Software Update Notification

PSS0017-05: Mastersizer 2000 E v5.60 software

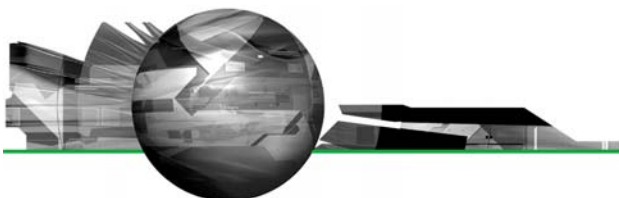
The following Software Change Requests (SCRs) have been implemented in version 5.60 of the Mastersizer 2000 software:
